RE RECONCILIATION OF THE CATHOLIC METROPOLITAN CEMETERIES TRUST (CMCT) MASTER PLAN PROPOSAL WITH THE ASSESSED CULTURAL SIGNIFICANCE OF VARRO VILLE'S CONTEXTUAL LANDSCAPE

As the principal author of a current study (with architectural colleague Peter Phillips) that is reviewing the curtilage of Varro Ville homestead and its integral outbuilding group, I write to you to explain the essence of the findings of the study (which is currently nearing completion) along with a brief reconciliation with the CMCT landscape master plan proposal for the lands comprising part of the former Varro Ville estate.

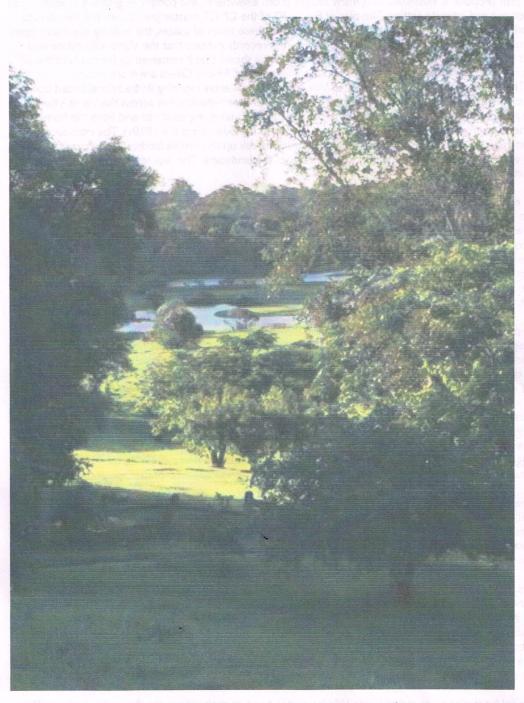
- * Through its deliberate siting, orientation and architectural design, the 1850s homestead of colonial architect William Weaver, as well as numerous places within the immediate grounds, engages with picturesque views across the western valley with a focal point on the existing dams (though, previously, a chain of ponds noted by James Meehan in 1809)(Figure 1). The reverse views are also important in an appreciation of the Varro Ville estate core within its traditional open rural landscape (Figure 2). The CMCT's proposed 'heritage curtilage' does not take these critical views into account.

Figure 3 View of the eastern valley from Lot 21.

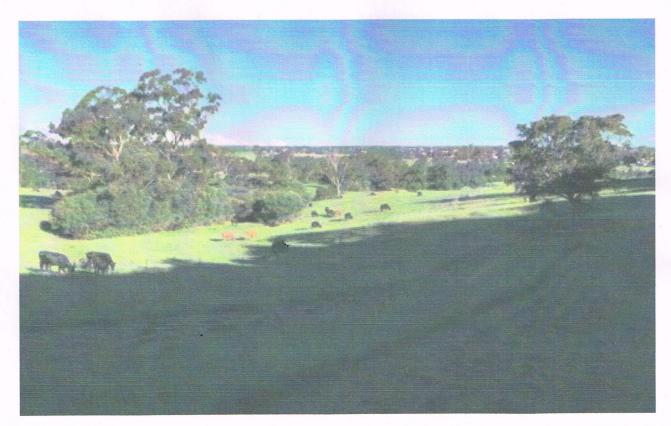
- * Additionally, important scenic views remain to and from the eastern valley that interpret how the pre-1850s estate core engaged with its immediate landscape setting (Figure 3). The CMCT's proposed 'heritage curtilage' does not take these critical views into account.
